Staff Report & Recommendation

Design Review Board

SUBJECT: DRB19-0424
6948-6988 Abbott Avenue and 6957-6965 Byron Avenue

X1.1 Revised parking screening along Abbott Avenue.

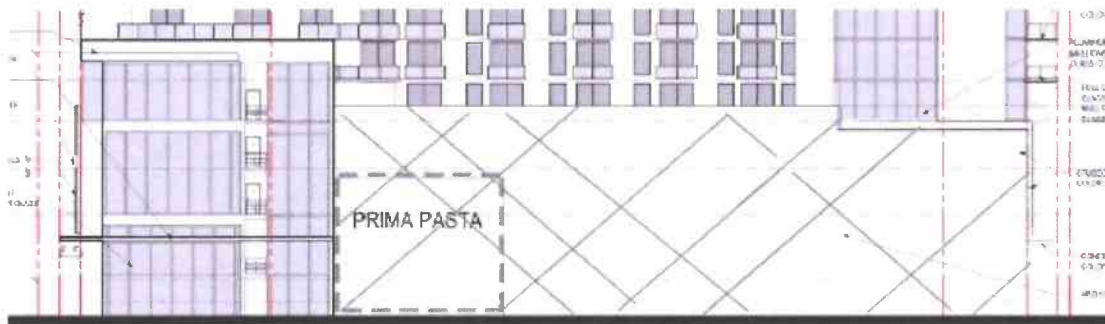
The applicant has presented a revised sheet depicting further refinement of the parking screening. The treatment continues to reinforce a “residential feel” with the use of warm metal panels, planters, and windows despite the lack of residential units within the levels of this portion of the building. Staff does not recommend that this modification move forward, as it does not improve an already unsuccessful architectural treatment.

- a. *Screening along the garage: The architect shall continue to refine the openings / apertures and eliminate those portions infilled with glass and suspended planter system along Abbot Avenue. The architect shall continue to refine the openings / apertures and redesign the juliet balconies infilled with glass and suspended planter system along Byron Avenue.*

X1.3 Mural concept along 71st Street.

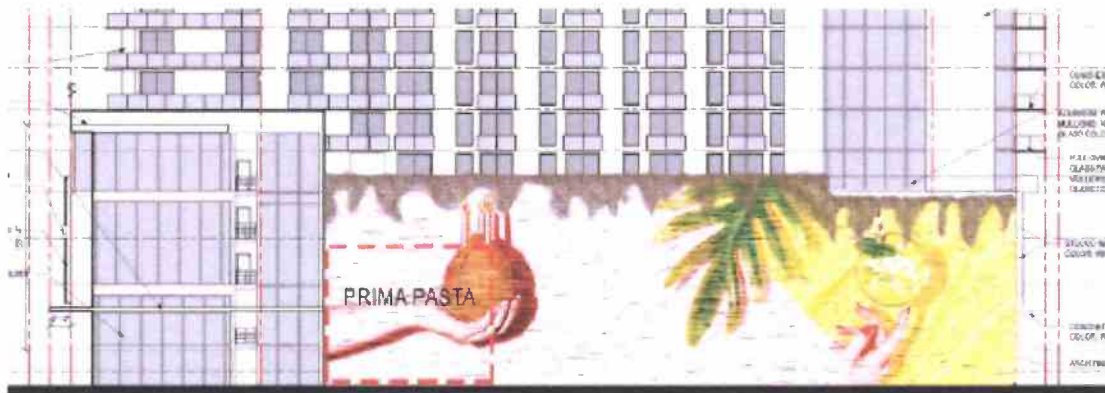
The applicant has proposed a possible mural to occupy the north wall facing 71st Street that is

partially obscured by the existing one-story restaurant. It appears to depict two separate hands holding two of Florida's citrus products, the lemon and the orange. This wall contains approximately 10,500SF of area. No additional information on the size, material finish or artist statement has been submitted. Again, any artistic murals are limited to a maximum aggregate size of 100 SF, unless otherwise approved by a majority vote of the city commission. Additionally, the top of the wall appears to contain a landscape species planted on the amenity level that is spilling over and onto the wall.

In general, staff would not recommend that an applied mural be utilized as the sole form of architectural design for this elevation. A mural could, potentially, be utilized in concert with other forms of architectural development for this elevation, as discussed herein.

- b. *Blank featureless walls: The architect shall further refine all featureless walls to incorporate a more articulated architectural treatment, including modifying the setbacks to allow for window openings, material and finish changes, introduction of changes in elevation to break up coplanar expanse, or the incorporation of a large scale artistic murals in order to minimize the stark appearance from the rights-of-ways and adjacent properties.*
